BRUCE H HAMILTON
Vice President
Oconee Nuclear Station

Subject: Duke Power Company LLC d/b/a Duke Energy Carolinas, LLC
Oconee Nuclear Site, Units 1, 2, and 3
Docket Numbers 50-269, 50-270, and 50-287
License Amendment Request for Low Pressure Service Water Reactor Building
Waterhammer Prevention System Modification to Mitigate Waterhammers
Described in Generic Letter 96-06 and Associated Technical Specifications
License Amendment Request (LAR) No. 2006-05

Subject: License Amendment Request for Low Pressure Service Water Reactor Building
Waterhammer Prevention System Modification to Mitigate Waterhammers Described
in Generic Letter 96-06 and Associated Technical Specifications
License Amendment Request No. 2006-05

Figure 1

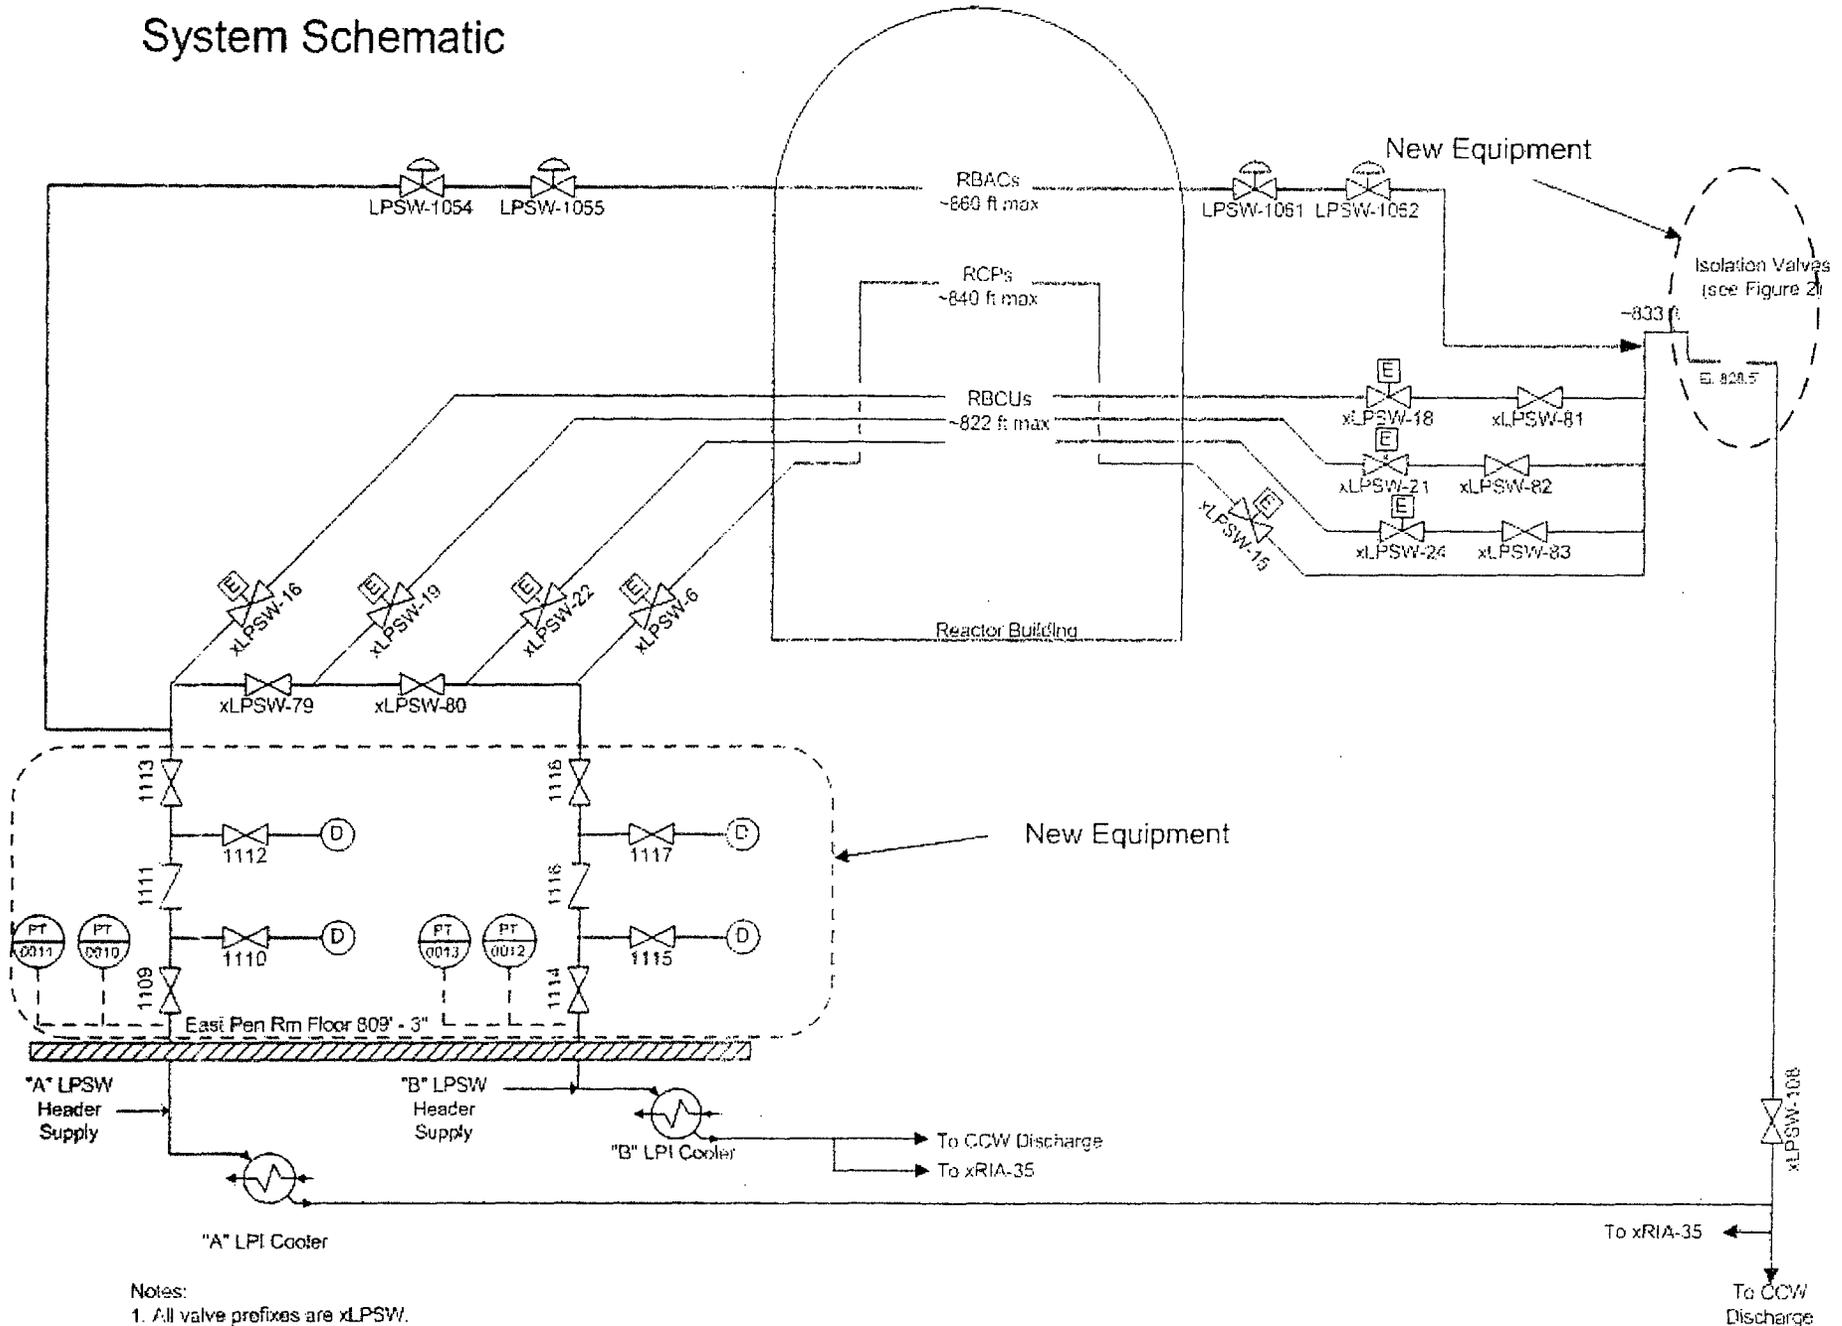
The modification will install new components in the two LPSW supply headers to the reactor building containment coolers (Reactor Building Cooling Units (RBCUs), Reactor Building Auxiliary Cooling Units (RBACs), and Reactor Coolant Pump (RCP) motor coolers) and a dual path in the common cooling water return piping. This equipment will be located outside of containment (see attached Figure 1 and 2 in attachment 1).

A check valve will be installed in each of the two supply headers. Isolation valves and test connections to allow maintenance and surveillance will be installed upstream and downstream of the check valves. The check valves will prevent drainage of the supply piping to the containment coolers when power is lost to the LPSW pumps. Also, the check valve elevation is low enough relative to the lake to prevent voiding upstream of the valve when it is closed.

Outside containment, the common LPSW return header will be split into two headers with a valve arrangement to create a diverse return path. Two pneumatic discharge isolation valves will be installed in each header. The two headers are rejoined downstream of the pneumatic discharge isolation valves into a common return. Isolation valves and test connections to allow for maintenance and surveillance will also be installed upstream and downstream of the pneumatic discharge isolation valves. This design allows the pneumatic discharge isolation valve arrangement to tolerate a single failure to close on demand. This design also allows the pneumatic discharge isolation valve arrangement to tolerate a single failure to open on demand. Thermal relief valves will be installed around the pneumatic discharge isolation valve arrangement to provide overpressure protection. Controllable vacuum breaker valves are installed downstream of the pneumatic discharge isolation valves in order to precondition the system for restart by breaking the vacuum in the downstream piping.

Figure 1 provides an overview of the LPSW system and associated cooling equipment inside the RB in its modified configuration.

Figure 2
 Direct RBCU/RCP Void Formation Prevention Strategy

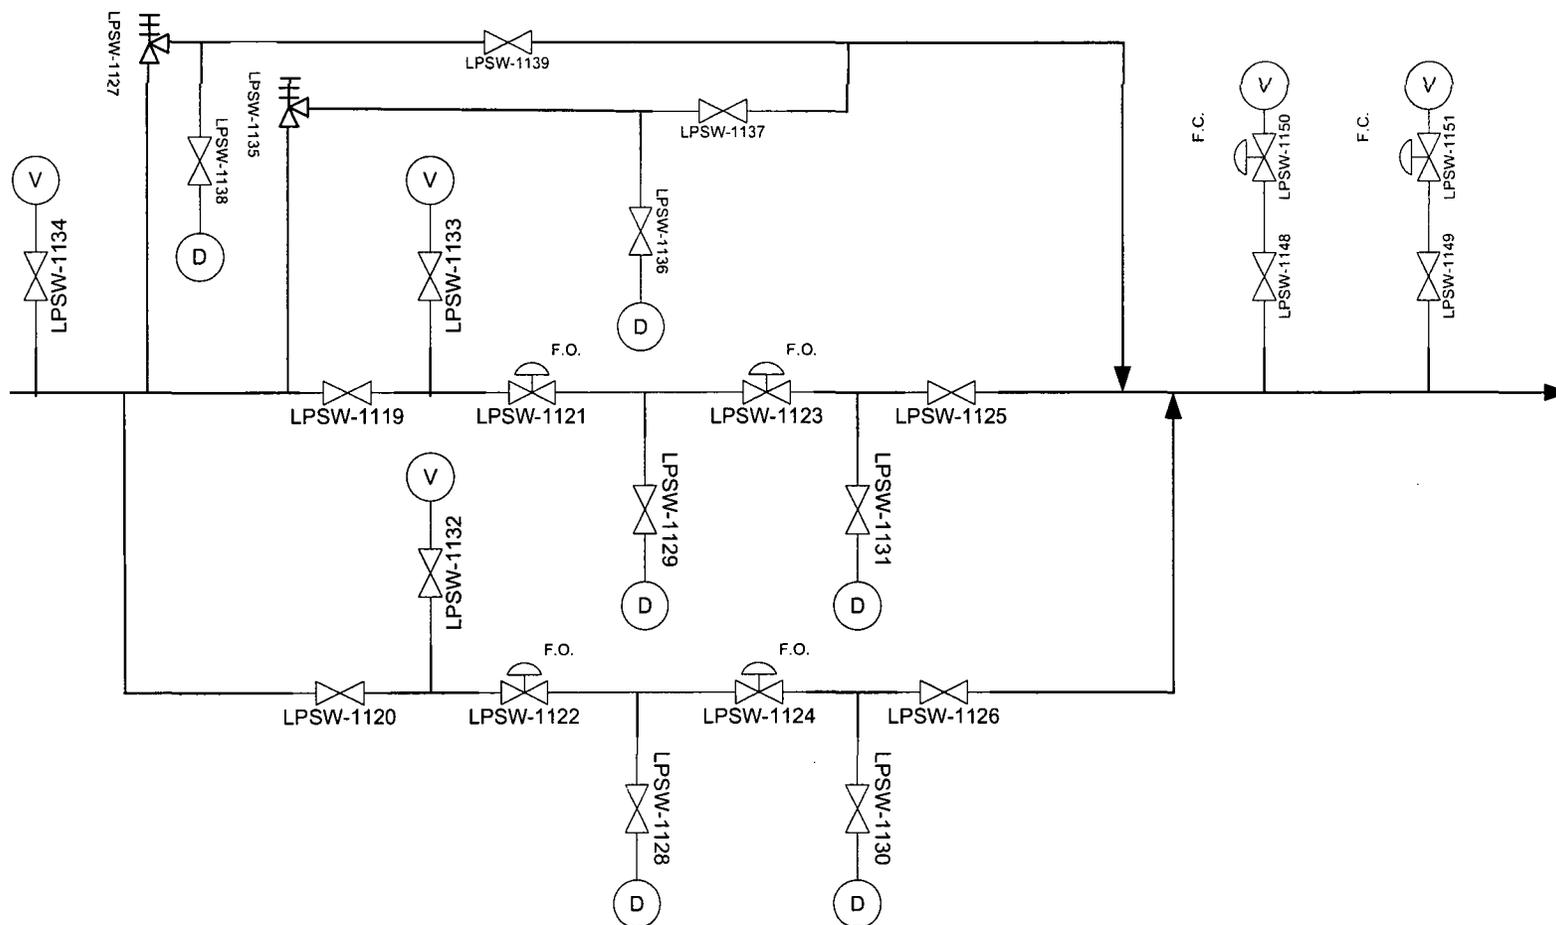
1. Control solenoid valves on pneumatic discharge isolation valves are energized to keep valves open. Loss of power to or failure of the solenoid valve will close the pneumatic discharge isolation valves.
2. Remote manual operation of the pneumatic discharge isolation valves from the Control Room is available to position valves as desired.
3. All pneumatic discharge isolation valves are maintained normally open to prevent a plant transient due to an on-line control solenoid valve failure.
4. Control solenoid valves for controllable vacuum breakers are energized to open.

FIGURE 3

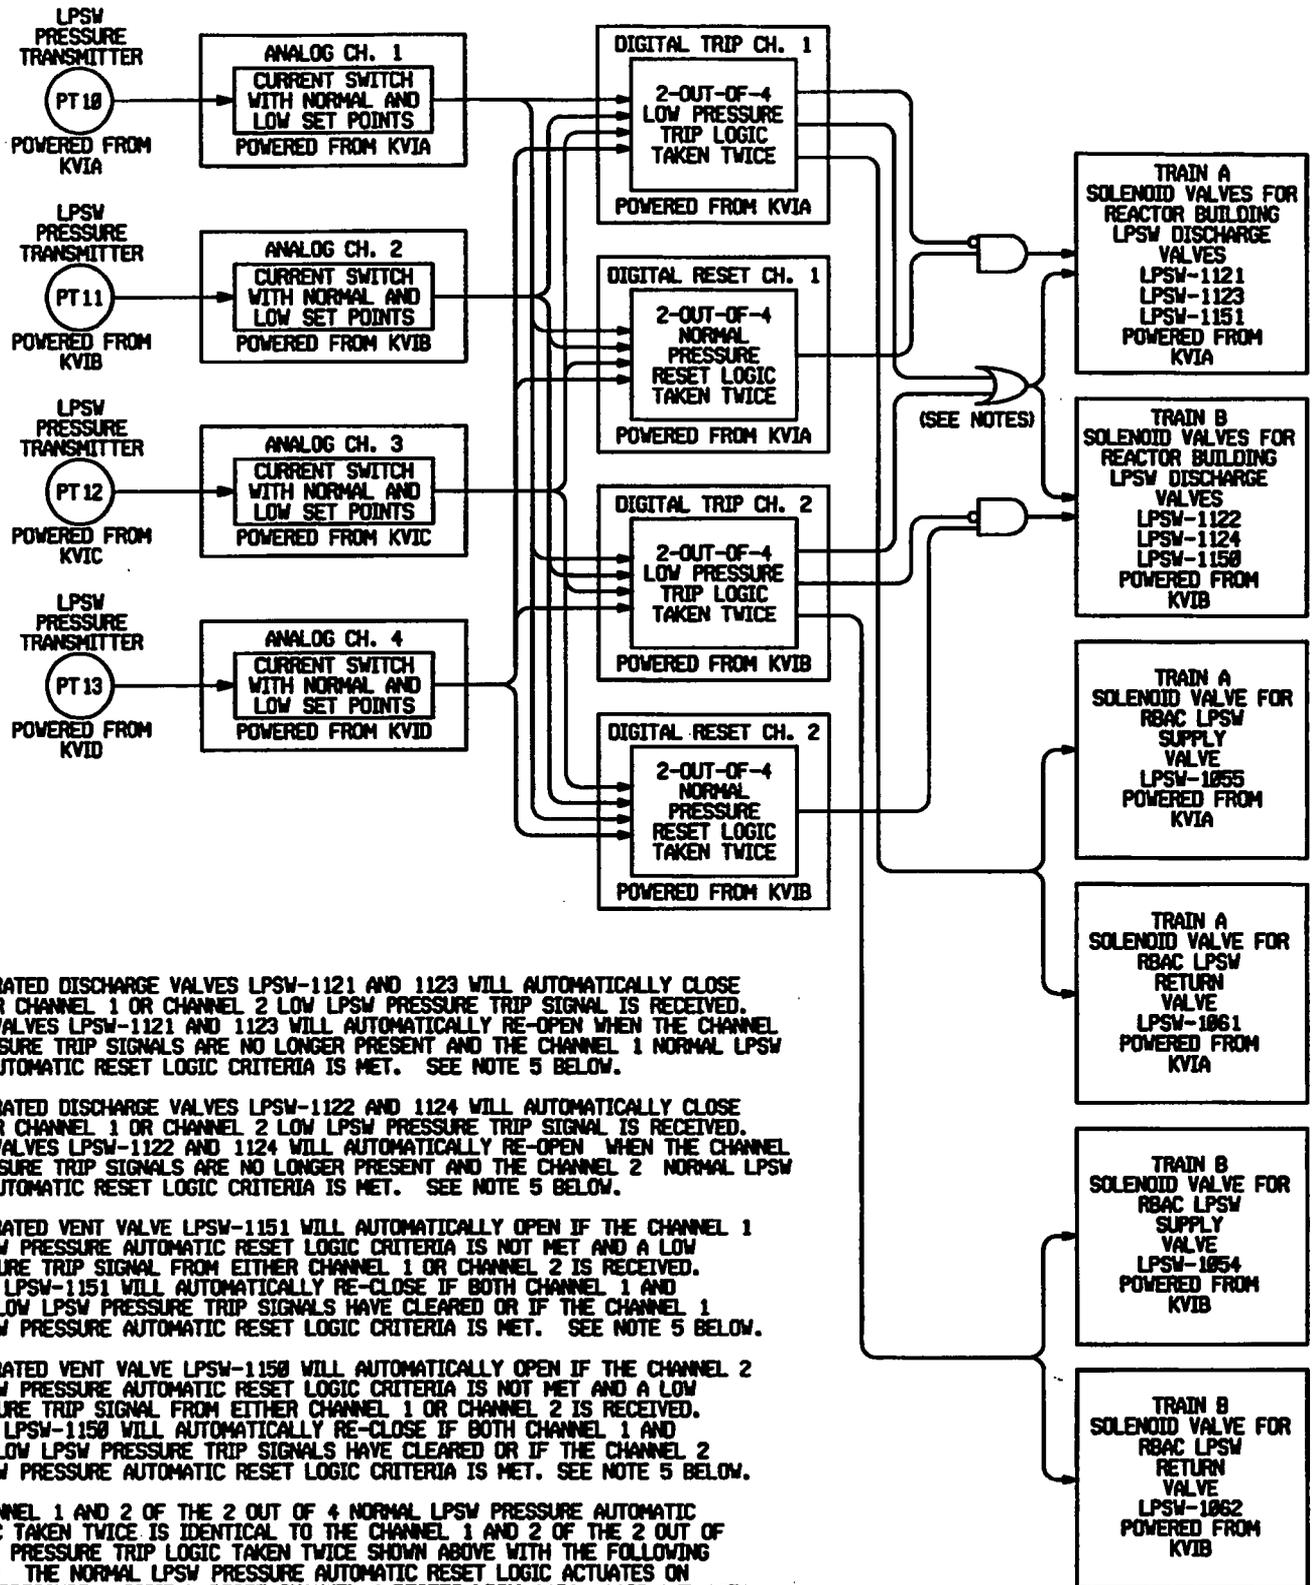
The pneumatic discharge isolation valves will be actuated by logic circuitry that is based on system pressure. With low and decreasing LPSW system pressure due to LOOP or loss of LPSW pumps, the waterhammer prevention logic circuitry will close the pneumatic discharge isolation valves. The isolation function is performed by one of two digital channels consisting of safety related relays, which are triggered by two of four analog channels, each consisting of a pressure transmitter/current switch. The valves will re-open on increasing supply header pressure (two of four analog channels activate the digital reset channels which are a two out of two logic). The pressure transmitters used to re-open the valves tap off the system upstream of the check valves. This is to prevent thermal effects due to a LOCA from pressurizing piping and inadvertently reopening the valves.

1. AIR OPERATED DISCHARGE VALVES LPSW-1121 AND 1123 WILL AUTOMATICALLY CLOSE WHEN EITHER CHANNEL 1 OR CHANNEL 2 LOW LPSW PRESSURE TRIP SIGNAL IS RECEIVED. DISCHARGE VALVES LPSW-1121 AND 1123 WILL AUTOMATICALLY RE-OPEN WHEN THE CHANNEL 1 LOW PRESSURE TRIP SIGNALS ARE NO LONGER PRESENT AND THE CHANNEL 1 NORMAL LPSW PRESSURE AUTOMATIC RESET LOGIC CRITERIA IS MET. SEE NOTE 5 BELOW.

2. AIR OPERATED DISCHARGE VALVES LPSW-1122 AND 1124 WILL AUTOMATICALLY CLOSE WHEN EITHER CHANNEL 1 OR CHANNEL 2 LOW LPSW PRESSURE TRIP SIGNAL IS RECEIVED. DISCHARGE VALVES LPSW-1122 AND 1124 WILL AUTOMATICALLY RE-OPEN WHEN THE CHANNEL 2 LOW PRESSURE TRIP SIGNALS ARE NO LONGER PRESENT AND THE CHANNEL 2 NORMAL LPSW PRESSURE AUTOMATIC RESET LOGIC CRITERIA IS MET. SEE NOTE 5 BELOW.

3. AIR OPERATED VENT VALVE LPSW-1151 WILL AUTOMATICALLY OPEN IF THE CHANNEL 1 NORMAL LPSW PRESSURE AUTOMATIC RESET LOGIC CRITERIA IS NOT MET AND A LOW LPSW PRESSURE TRIP SIGNAL FROM EITHER CHANNEL 1 OR CHANNEL 2 IS RECEIVED. VENT VALVE LPSW-1151 WILL AUTOMATICALLY RE-CLOSE IF BOTH CHANNEL 1 AND CHANNEL 2 LOW LPSW PRESSURE TRIP SIGNALS HAVE CLEARED OR IF THE CHANNEL 1 NORMAL LPSW PRESSURE AUTOMATIC RESET LOGIC CRITERIA IS MET. SEE NOTE 5 BELOW.

4. AIR OPERATED VENT VALVE LPSW-1150 WILL AUTOMATICALLY OPEN IF THE CHANNEL 2 NORMAL LPSW PRESSURE AUTOMATIC RESET LOGIC CRITERIA IS NOT MET AND A LOW LPSW PRESSURE TRIP SIGNAL FROM EITHER CHANNEL 1 OR CHANNEL 2 IS RECEIVED. VENT VALVE LPSW-1150 WILL AUTOMATICALLY RE-CLOSE IF BOTH CHANNEL 1 AND CHANNEL 2 LOW LPSW PRESSURE TRIP SIGNALS HAVE CLEARED OR IF THE CHANNEL 2 NORMAL LPSW PRESSURE AUTOMATIC RESET LOGIC CRITERIA IS MET. SEE NOTE 5 BELOW.

5. THE CHANNEL 1 AND 2 OF THE 2 OUT OF 4 NORMAL LPSW PRESSURE AUTOMATIC RESET LOGIC TAKEN TWICE IS IDENTICAL TO THE CHANNEL 1 AND 2 OF THE 2 OUT OF 4 LOW LPSW PRESSURE TRIP LOGIC TAKEN TWICE SHOWN ABOVE WITH THE FOLLOWING EXCEPTIONS: THE NORMAL LPSW PRESSURE AUTOMATIC RESET LOGIC ACTUATES ON INCREASING PRESSURE. DIGITAL RESET CHANNEL 1 RESETS LPSW-1121, 1123 AND 1151 VALVES ONLY. DIGITAL RESET CHANNEL 2 RESETS LPSW-1122, 1124 AND 1150 ONLY. ACTUATION OF EITHER DIGITAL RESET CHANNEL 1 OR DIGITAL RESET CHANNEL 2 WILL RESTORE AN ES SUCCESS FLOW PATH.
